**DRAFT- DOH Review:**  
**Navy Groundwater Flow Models & Related Issues with**  
**the Navy CSM for the Red Hill Facility**

*The Department of Health Hawaii (DOH)*  
*Technical subject matter experts*  
*Robert Whittier, Don Thomas, G.D. Beckett & Anay Shende*

*October 19, 2021*

# Lab vs. Field Scale – Permeability

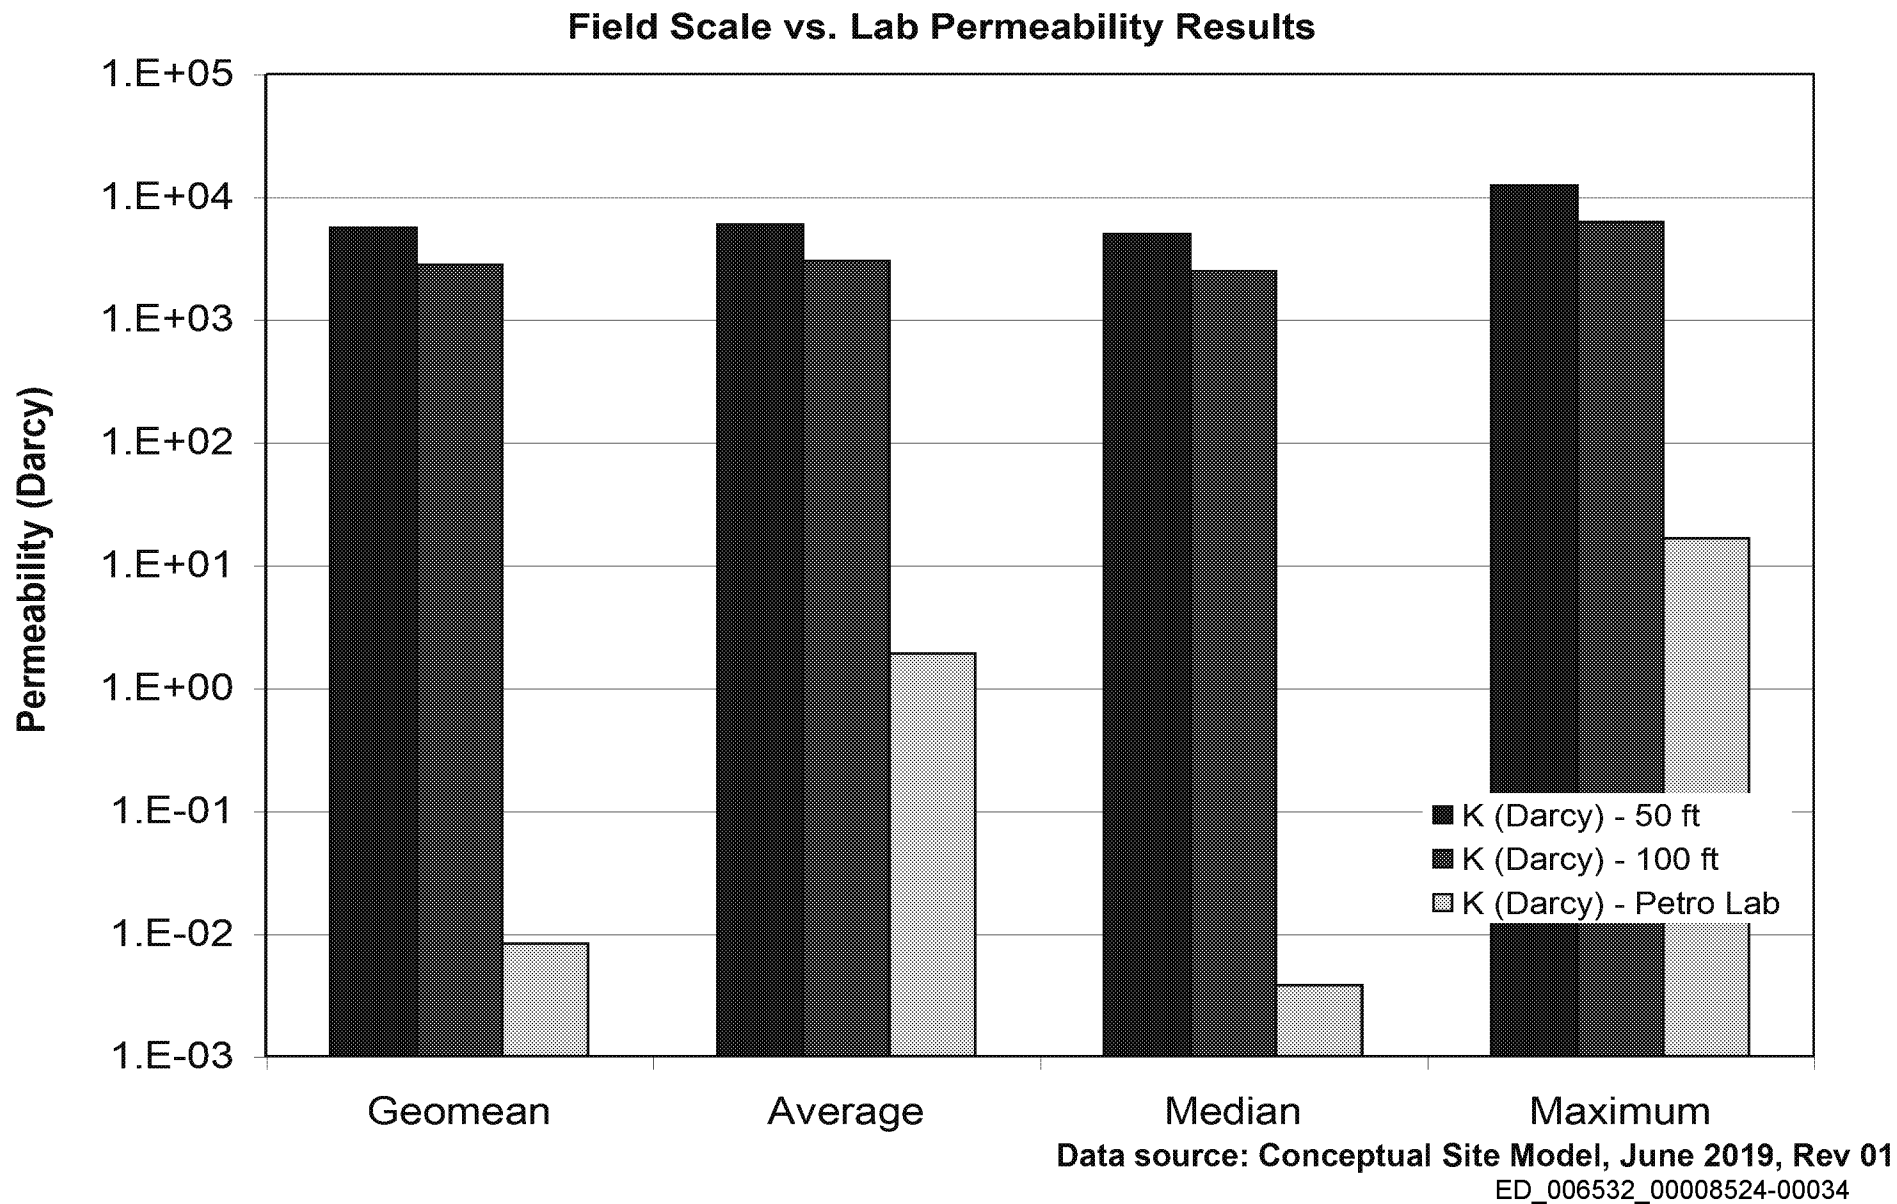
*(Site lab data are not comparable to field scale)*
